MOORE-SUSSEX PLACE ESTATES SUBDIVISION

APPLICATION NUMBER 6 DATE February 16, 2017

DETAIL SITE PLAN

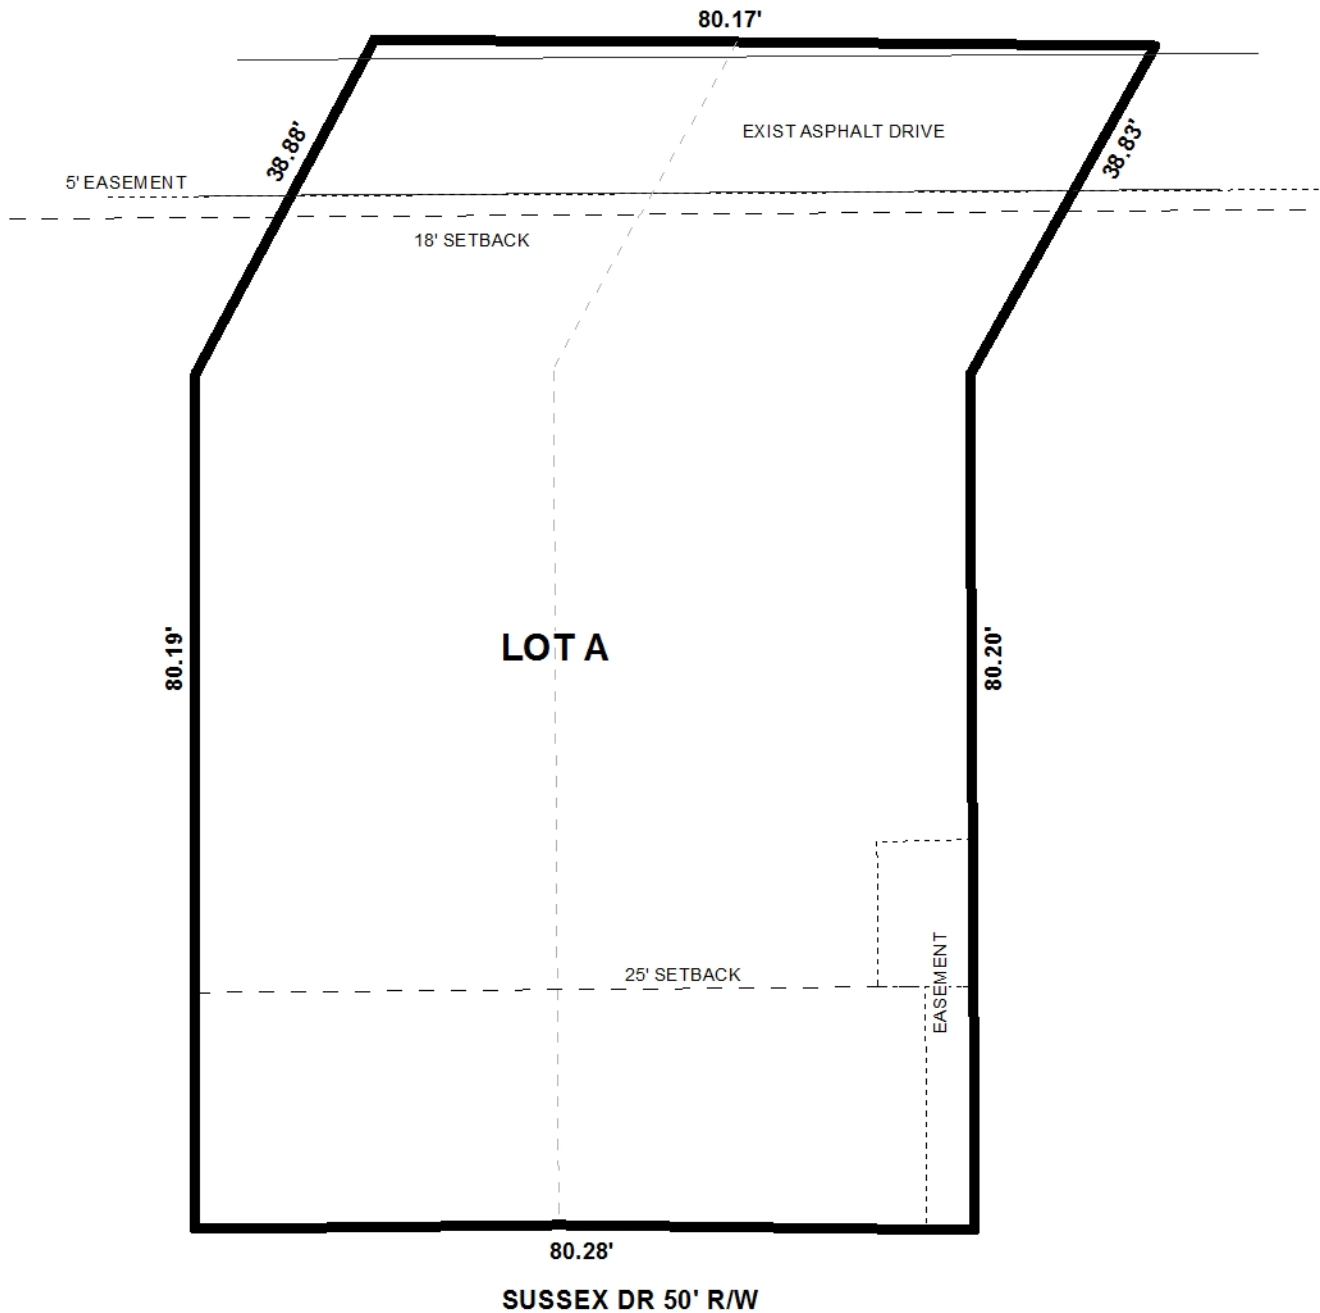
The proposed 80'± wide, 9,130± square feet lot has frontage on Sussex Drive, a minor street with curb and gutter requiring a right-of-way width of 50 feet. The preliminary plat illustrates an existing right-of-way width of 50 feet; therefore, no additional dedication should be required.

It should be noted that the proposed lot is accessed via a private alley in the rear of the property, the result of an 18' reciprocal easement; and, as such, access to Sussex Drive should be denied.

The proposed lot meets the minimum size requirements of Section V.D.2. of the Subdivision Regulations and is illustrated in both square feet and acres. This information should be retained on the Final Plat, or a table furnishing the same information should be provided on the Final Plat, if approved.

The 25-foot minimum building setback is illustrated on the preliminary plat. If approved, this information should also be retained on the Final Plat.

A note on previous plats states the lots were approved for 0' side yard setbacks, to which Staff mentioned the subdivision was originally approved at the November 1, 1979 meeting of the Planning Commission, prior to the adoption of regulations regarding Planned Unit Development; and, as such, similar approval of reduced side yard setbacks was appropriate. However, the applicant has revised this note on the preliminary plat to indicate compliance with minimum setback requirements of the underlying zoning district. If approved, this note should be retained on the final plat, or a note stating the lots are approved for 0' side yard setbacks should be provided.

Finally, in addition to the aforementioned reciprocal easement, there is a 150 s.f. utility easement behind the 25' minimum building setback line along the East property line of the proposed lot, a 5' easement within the 25' minimum building setback line, and a 5' gas line easement in the rear of the proposed lot. A note on the preliminary plat states that no structures will be erected in any easements, and should be retained on the Final Plat, if approved.

- 1) placement of a note on the Final Plat stating that the lot is denied access to Sussex Drive;
- 2) retention of the lot sizes in square feet and acres on the Final Plat, or the furnishing of a table on the Final Plat providing the same information;

- 3) retention of the 25' minimum building setback line on the Final Plat;
- 4) placement of a note placed on the Final Plat stating that no structures will be erected in any easements;
